TILLAMOOK COUNTY PLANNING COMMISSION

#851-21-000095-PLNG: A request for preliminary subdivision plat approval of a 58-lot subdivision identified as "Second Addition to Avalon Heights" on a property located within the Unincorporated Community of Oceanside, together with Geologic Hazard Report review request #851-21-000202-PLNG. The subject property is located within the Oceanside Unincorporated Community boundary and accessed via Highland Drive and Grand Avenue, County local access roads, and is designated as Tax Lot 200 of Section 30DC, Township 1 South, Range 10 West of the Willamette Meridian, Tillamook County, Oregon.

Date: July 1, 2021
To: Tillamook County Planning Commission
From: Melissa Jenck, CFM, Land Use Planner II
Subject: Subdivision Request #851-21-000095-PLNG “Second Addition to Avalon Heights”

Per your request, we have reviewed the land use application and associated preliminary site & utility drawing submitted for the "2nd Addition to Avalon Heights Subdivision". This property is located at the north end of Netarts (*ie. generally located just south of the boundary between Netarts and Oceanside, at the east edge of the CGB*).

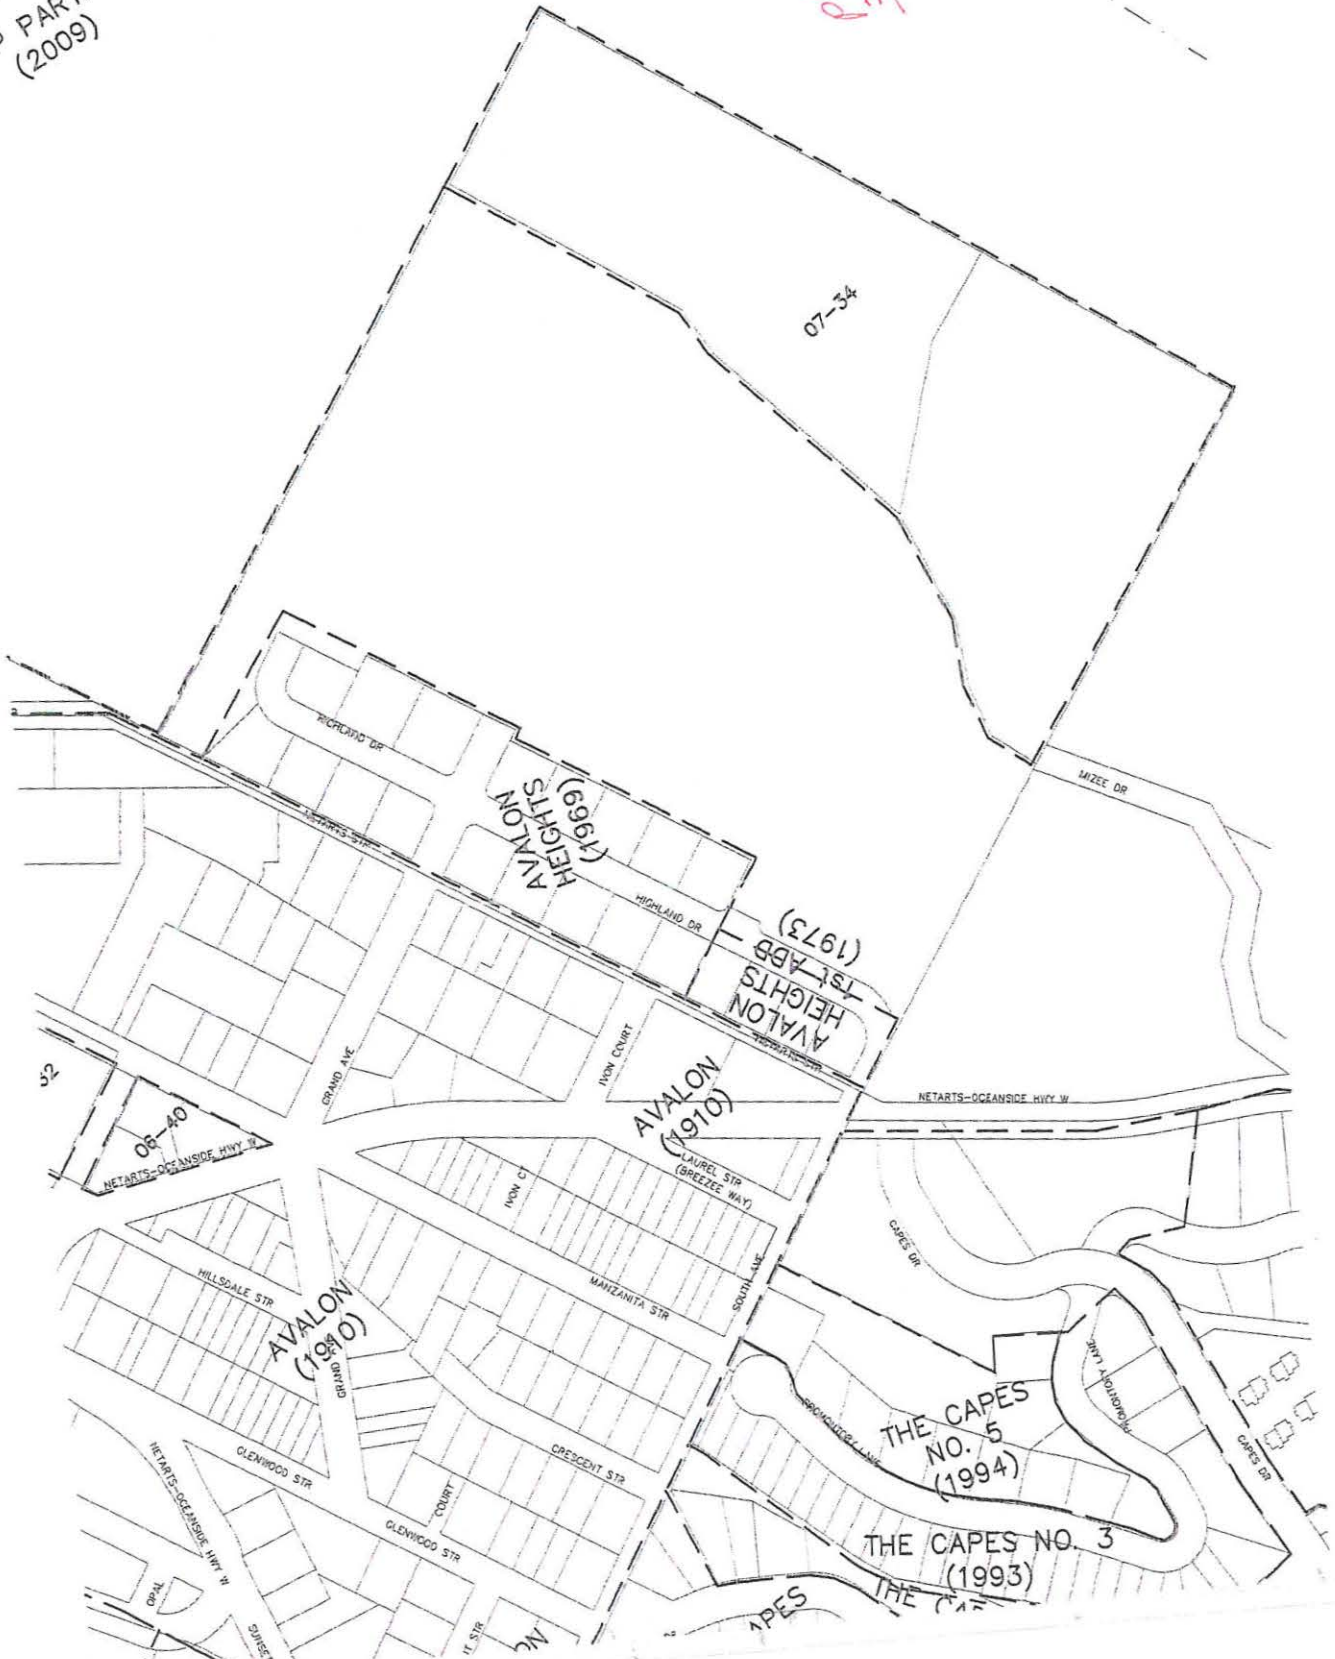
Excerpts from the NOSD sewer system maps are attached for reference. These maps show the approximate location and layout of the surrounding properties and known sewer utilities.

PRELIMINARY PLAT
SECOND AVALON HEIGHTS SUBDIVISION
LAND USE PLANS

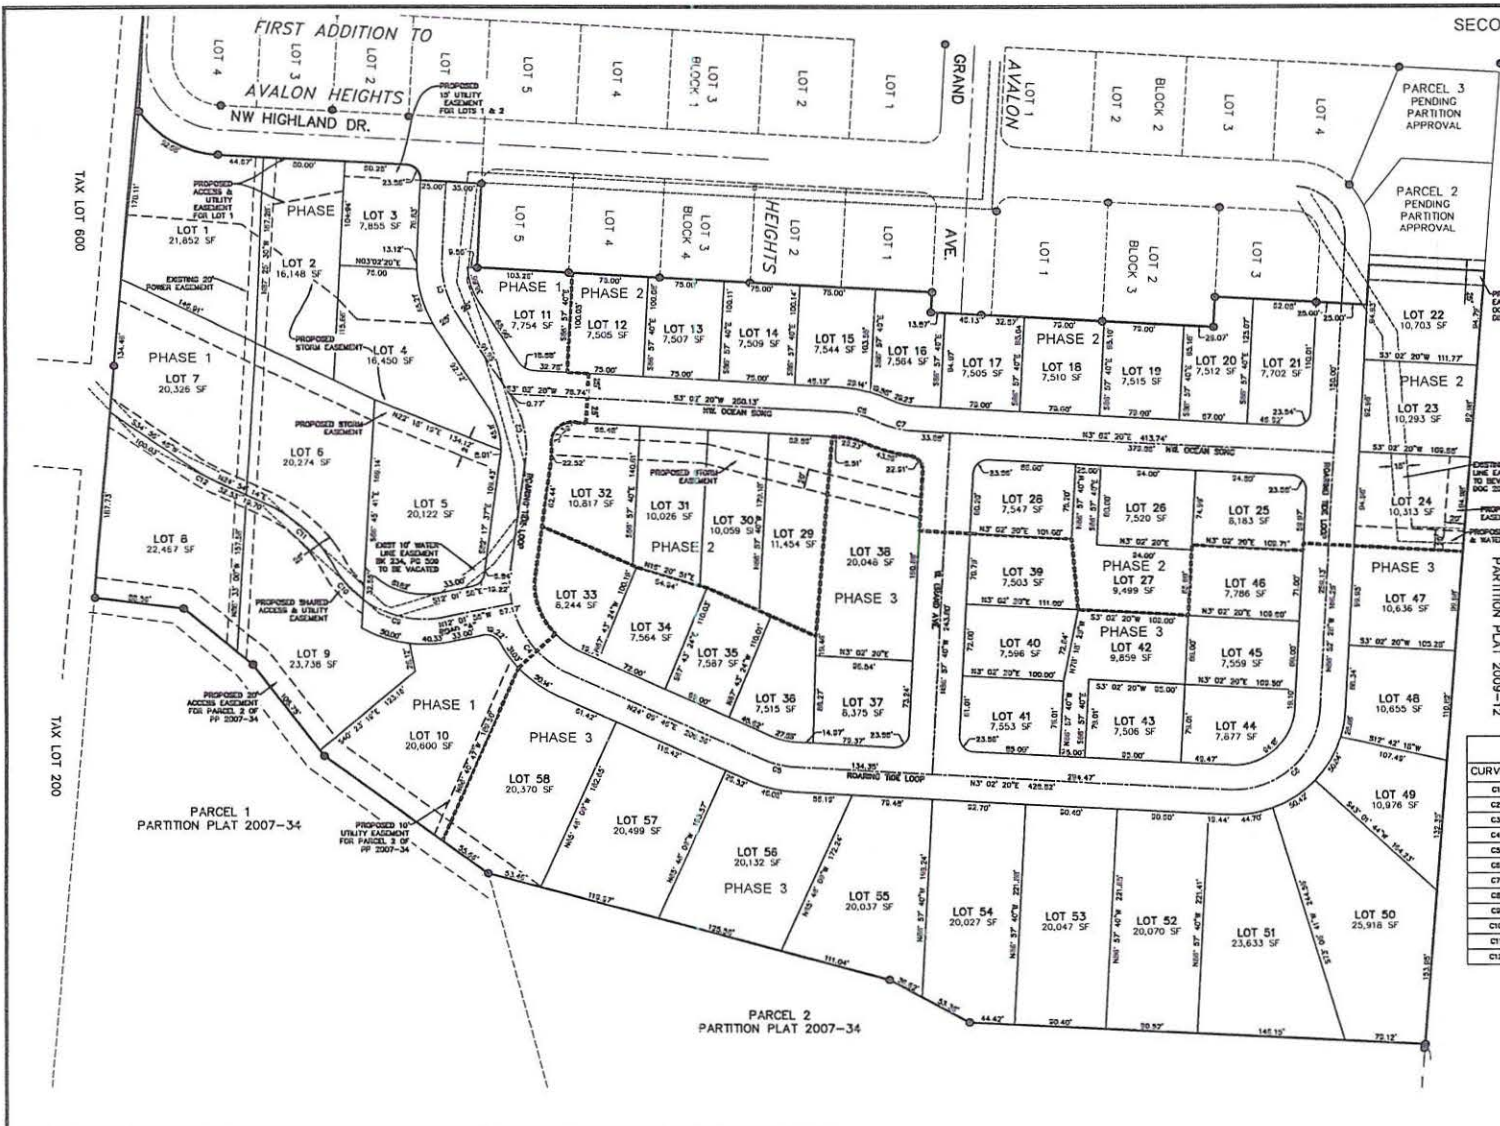
The Existing Conditions (2/14) sheet of the preliminary drawings provided do not show or have callouts corresponding to the existing easements listed in the title report. However, this drawing sheets does show a power easement which is not listed in the title report. This will need to be clarified as part of the final design.

The County staff report indicates that the developer is proposing to construct the project in 3 phases (*see also Sheet 4/14 of the preliminary drawings*).

The application drawings include a site layout drawing and preliminary grading contours.

- The developer shall submit sanitary sewer drawings conforming to the requirements of the PWDS, including new mainlines at depths conforming with NOSD standards, including being deep enough to provide for gravity sewer service to building envelopes on the low side of streets. Gravity sanitary sewer mainlines and/or service laterals shall be provided to serve all existing, proposed and potential lots within the development or fronting on the new streets.

- The developer shall have the option of constructing the development in a maximum of 3 phases. The sewer, site, grading, access & utility design for the entire project be required to be shown prior to start of construction on Phase 1. The installation of access drives & sewer utilities in each phase shall be sufficient to meet all NOSD standards and to ensure service to and connection into the subsequent phase and to provide service to upstream properties as applicable, and to ensure that maintenance access is provided per NOSD standards, with the District Engineer and NOSD Superintendent determining the appropriate level of improvements required to comply with this condition.

- Except as specifically modified by this land use decision, the developer shall be responsible to obtain site / street / utility construction permits (*and commence substantial construction*) within 18 months of the date that the land use approval is final, or the land use approval will expire unless an extension is granted (*this does not require that all construction to be complete within the 1½ year period*).
- All Phase 1 improvements shall be completed within 3 years of the date that the land use approval is final. Construction of Phase 2 improvements shall commence within 2 years of the date that the Phase 1 construction is completed and approved by the County & NOSD, and the construction of improvements for each subsequent phase shall commence within 2 years of the date of permit issuance for the previous phase, or the land use approval will expire unless an extension is granted.
